Pentland Floating Offshore Wind Farm

Section 36C Consent and Marine Licence Variation Application Report

Document No.	GBPNTD-PGM-PEN-RP-00003
Project:	Pentland Floating Offshore Wind Farm
Originator Company	HWL
Revision	01
Author	HWL
Date	11.10.2023

Figure S32C-7a
Viewpoint 7: Dunnet Head Wireline

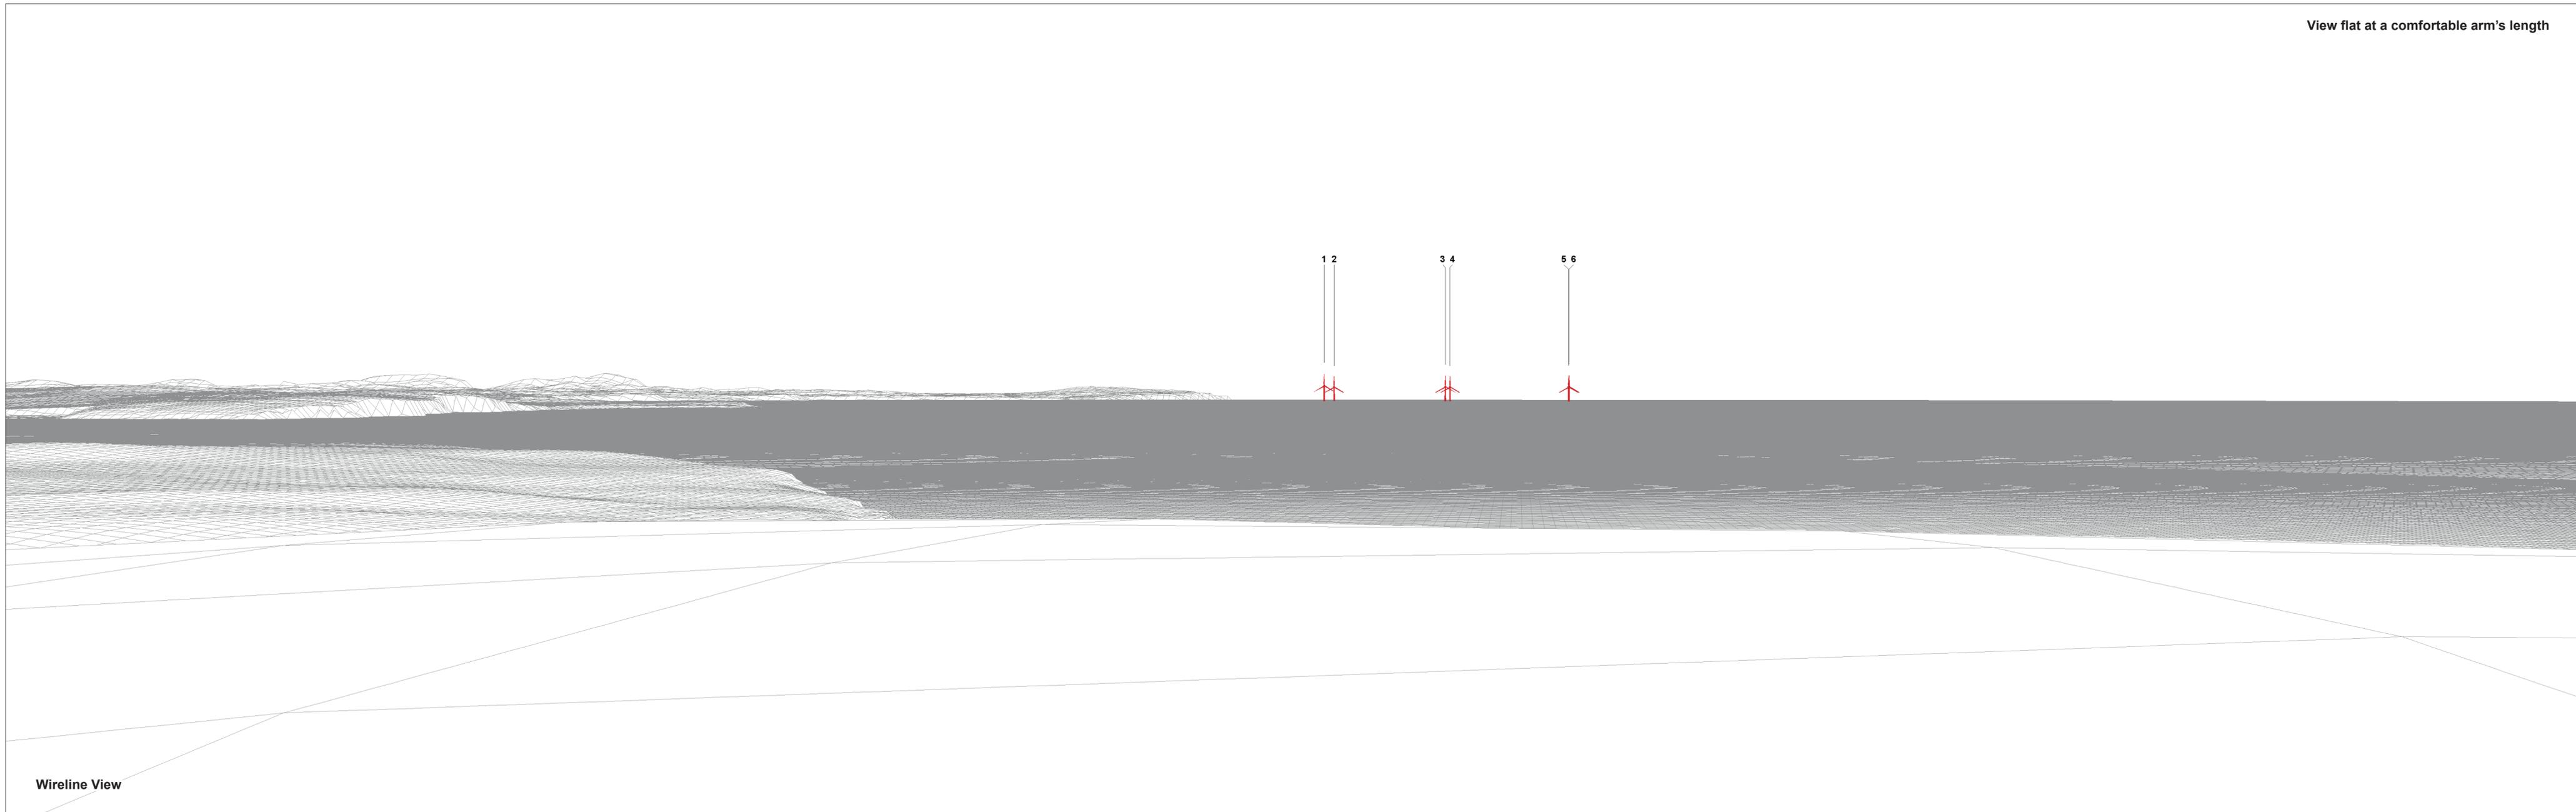
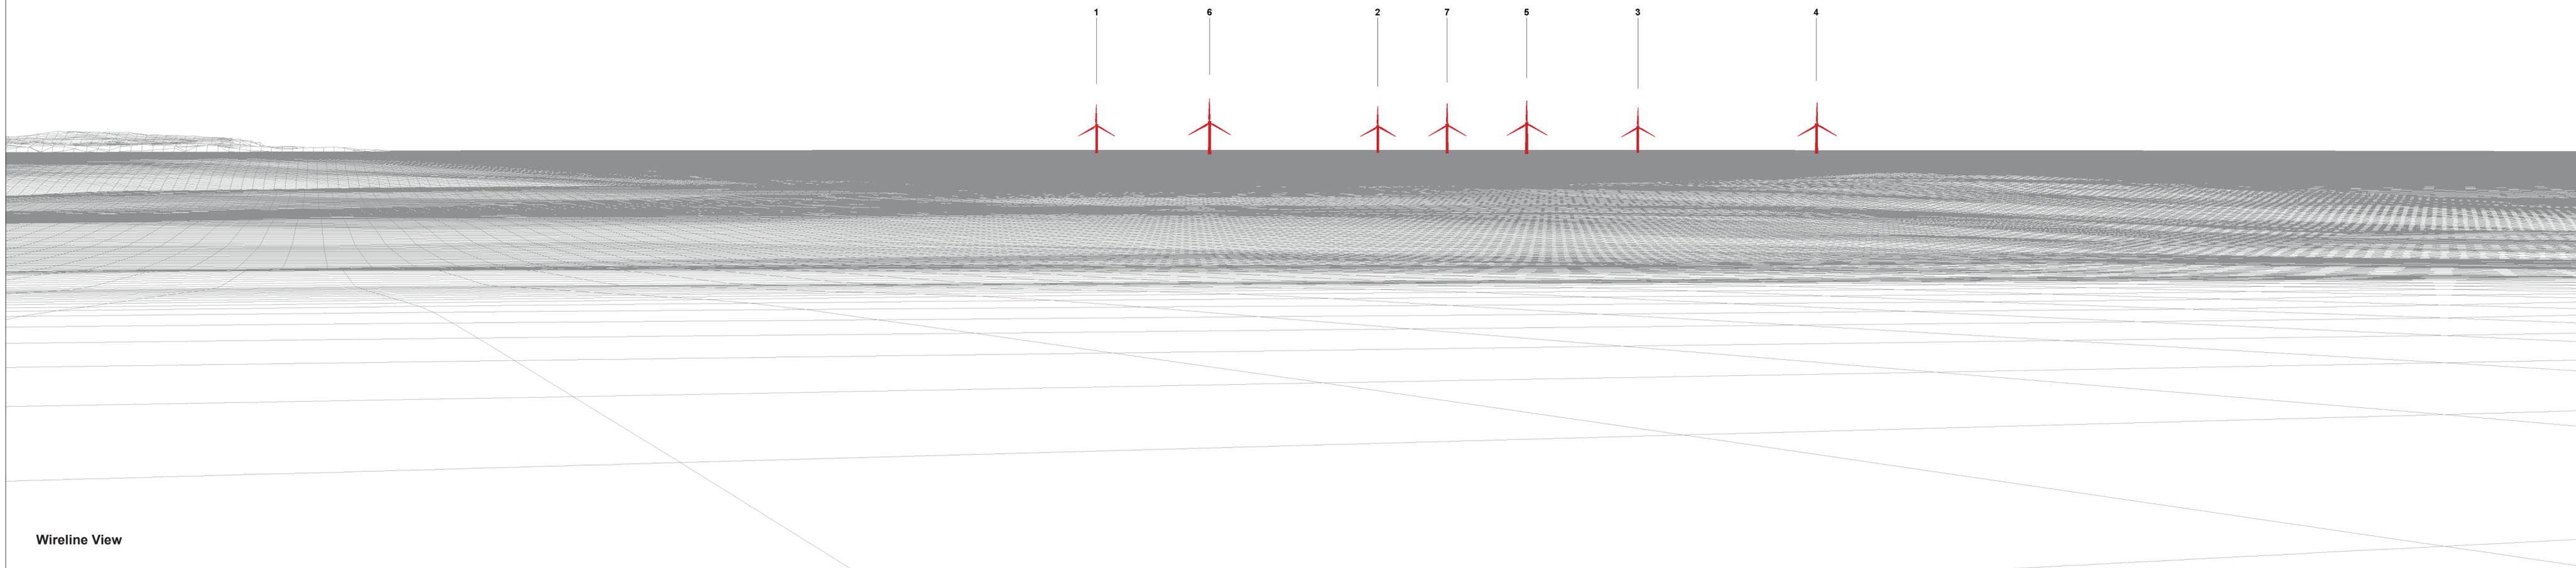
7 Dunnet Head	<p>Sensitivity - medium-high</p> <p>Magnitude of change – medium-low</p> <p>Significant at a moderate level</p>	<p>Reduction in horizontal extent apparent, albeit less so from more distant range and with grouping of WTGs remaining. Although there would be a slight reduction in MoC, overall assessment would remain unaltered owing to incremental nature of reductions and moderating effect of separation distance and other distant wind farm influences.</p> <p>Any differences in blade tip height between the WTGs will not be discernible from this viewpoint owing to the separation distance of 28 km.</p>
10 A836 East of Forss	<p>Sensitivity - medium-high or medium</p>	<p>Reduction in horizontal extent readily apparent and WTGs appear very evenly spaced.</p>

Figure 1 PFOWF Variation Application proposal, showing the revised array area (the WTG Footprint Area) in pink

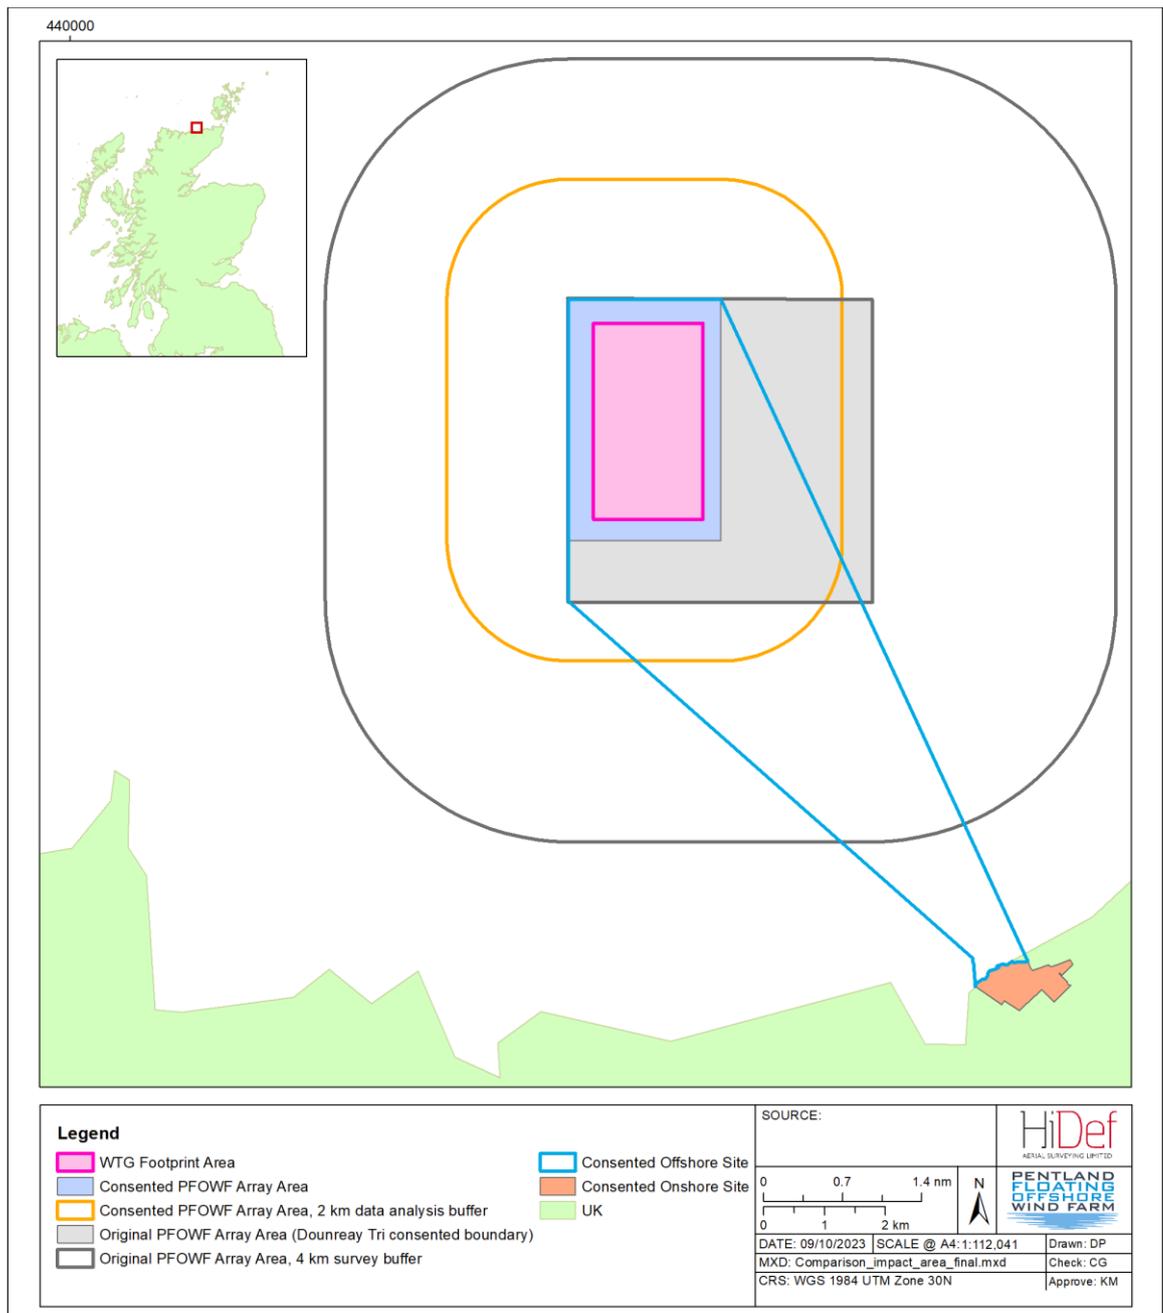
- 3 As set out in the Variation Application Report, following detailed design work and in response to the concerns raised by NS, the Project's design envelope has been further refined which has led to a corresponding reduction in predicted impacts on kittiwake and puffin. This has been achieved by reducing the maximum number of wind turbine generators (WTG) from seven to six, as well as by reducing the size of the area in which the turbines will be placed (the WTG Footprint Area), as shown on Figure 1 (reduced from 10 km² in the Original Application and current consent to 5.85 km²).
